Providence City Plan Commission

February 21, 2023

AGENDA ITEM 5 ■ 50 BRANCH AVE

Site Plan

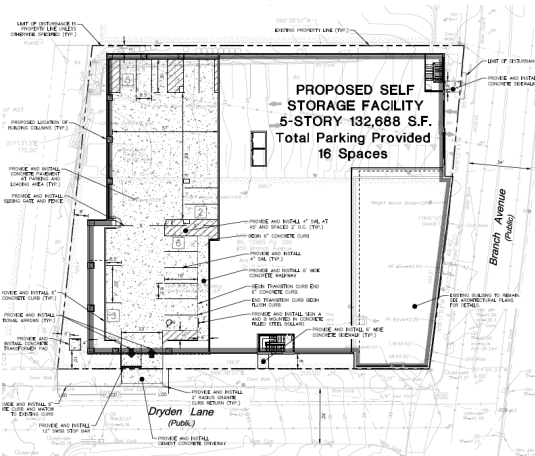
Approximately 5,250 SF of canopy coverage—five large trees and one small—is required to meet the landscaping requirement based on the size of the development. According to the conceptual landscaping plan, shrubs and plantings will be made in the front, side and rear yard. The plan does not currently include trees. Per the City Forester, the applicant may make offsite plantings to meet the requirement.

A detailed landscaping plan that includes the tree species, their location, and the canopy coverage calculation shall be included with the preliminary plan.

The development requires 28 spaces, calculated as one space per 50 storage units, but 16 will be provided. A dimensional adjustment for 12 spaces is requested. Based on a review of plans, it appears that the adjustment is being requested due to the physical characteristics of the lot whose grade does not allow for the location and circulation for the required amount of parking. Based on an analysis provided by the applicant, the storage space use will not generate traffic that requires more parking than what is provided. Therefore, the DPD recommends that the CPC grant the requested adjustment.

Two loading spaces are also required as the building will provide over 100,000 SF of space. A loading area is identified at the rear of the parking area, but the spaces are not demarcated. The loading area can accommodate the two spaces with dimensions of 10' in width, 22' in length and a 10' clearance. The loading spaces shall be defined in the preliminary plan.

The applicant is requesting a design waiver from the corner side yard build-to percentage requirement on Dryden Lane. The portion of the existing building that will be preserved is set to the side lot line, but the rest of the structure extending to the rear of the lot will be set 8' from the side lot line—outside of the 5' build-to zone. A 6' walkway and landscaping is proposed within this setback. The DPD is not opposed to granting the waiver as it would enhance pedestrian movement and increase opportunities for landscaping.

1. The applicant shall provide a detailed landscaping plan at the preliminary plan stage.
2. The loading spaces shall be defined on the preliminary plan.
3. The preliminary plan shall include more transparent areas on the upper stories and include a transparency calculation.
